PECO NUCLEAR

10CFR 50.90
GL 97-04

Subject: Peach Bottom Atomic Power Station, Units 2 and 3
Response to May 10, 2000, Telephone Questions Regarding
PECO Energy License Amendment Request Related to
Generic Letter 97-04

FIGURE 5.2.16 Rev. XX XX/XX

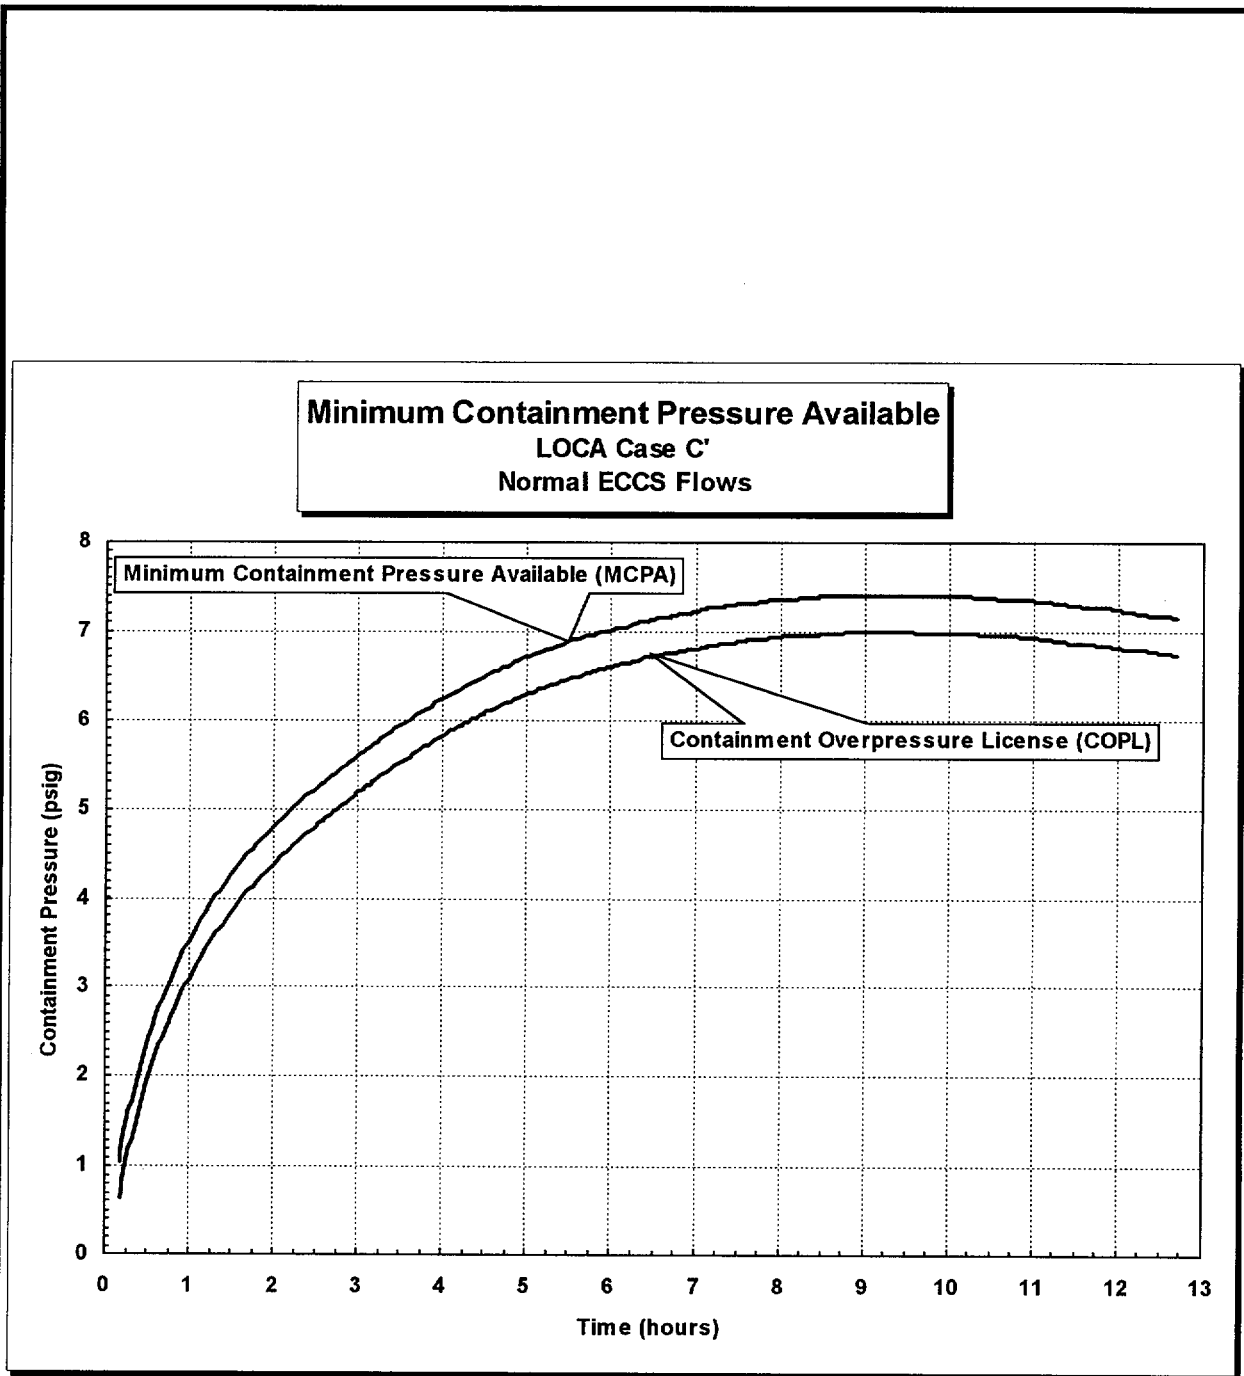
Explain why the containment overpressure license (COPL) depicted in the proposed UFSAR figure 5.2.16 is different than the containment overpressure required (COPR) curve in the presentation attached to the PBAPS submittal (i.e., COPL is greater than COPR).

Confirm that the requested containment overpressure license curve is applicable to both the RHR and core spray pumps. Which pumps have a higher requirement for containment overpressure (RHR or core spray) for a design basis LOCA?

The PBAPS MCPA analysis (PM-1013) determined a conservative estimate for the minimum containment pressure that will be available during a design basis LOCA, including design basis containment leakage and use of containment sprays in accordance with plant emergency procedures. The COPL is developed from the MCPA analysis for the design basis LOCA by providing some additional margin (i.e., conservatism) from the MCPA analysis results, as discussed and agreed upon in the November 18, 1998 meeting between NRC Staff and PECO Energy Company personnel. This development of the COPL is explained below.

As discussed in the November 18, 1998 meeting and documented in the Referenced submittal, a significant amount of containment overpressure credit is required (COPR) to ensure proper operation of the RHR and Core Spray pumps for the Design Basis Accident (DBA) LOCA at PBAPS Units 2 and 3. Therefore, the margin between MCPA and COPR is relatively small. Given that, COPL was defined in such a way as to provide regulatory margin below the MCPA, while providing some licensee margin for minor design changes which could affect the COPR. Allowing for margin in both directions in the establishment of the COPL should minimize the need for subsequent licensing actions while providing additional assurance beyond the conservative minimum containment pressure analysis that sufficient ECCS pump NPSH will always be available for DBA LOCA events.

With regard to specifics, the minimum margin between MCPA and COPR is 1.3 psig, and occurs at the maximum suppression pool temperature of 205.7°F. Verbal agreement was reached during the 11/18/98 meeting that it would be reasonable to establish the COPL at a value (or series of values) less than the MCPA by 1 foot. This is the approach that was taken in the Reference submittal.

Note that the MCPA is event specific and system independent, while COPR is both event and system dependent. The COPL is event and system independent (it is a defined curve or set of values), although it is based on the design basis LOCA MCPA, since this is the event that requires the most credit for containment overpressure.

The COPL indicated on the proposed UFSAR Figure 5.2.16 is applicable to both the RHR and core spray pumps. The RHR pumps have a higher requirement for containment overpressure for the design basis LOCA. The COPL represents the maximum containment overpressure credit that can be taken for PBAPS, Units 2 and 3 design basis accident analysis. Note that although COPL represents the maximum credit, the analytical credit may not exceed the containment overpressure available for the specific event being analyzed.
